Service Bulletin

Bulletin No.: PI1178

Subject: Engine Rough Run with Check Engine Light (CEL) On/Low Compression on Cylinder with Misfire, DTC P0300 Set

Models: 2013 Cadillac ATS
2013 Chevrolet Malibu
Equipped with 2.0L Turbo Engine (RPO LTG)

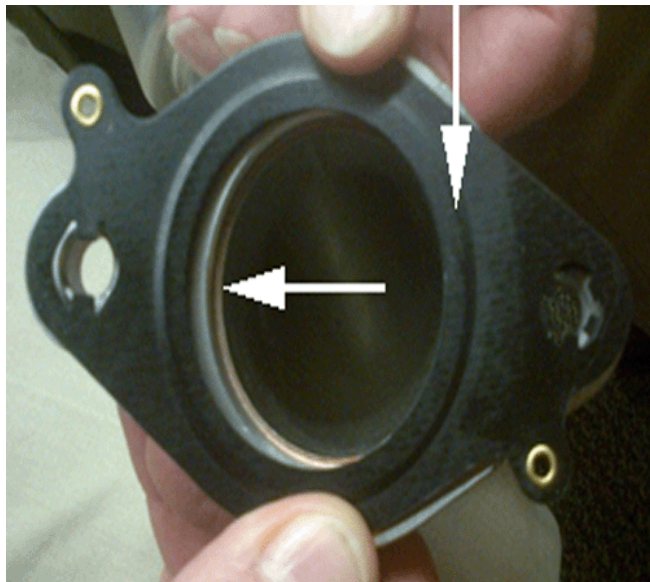
This condition may be caused by a piston in that cylinder cracked between the piston compression rings.

Perform a leak down test on the affected cylinder making sure the misfire is caused by piston leakage and leakage into the crank case. Visually inspect the spark plug and replace if damaged. The coil connections for the affected cylinder should also be visually checked for damaged terminals. Some light vertical marks may be visible on the cylinder wall. In these areas, check that the honing marks are still visible in this marked area. If they are, the cylinder surface has not been compromised and the engine block can be used. All 4 piston assemblies should be replaced at this time.
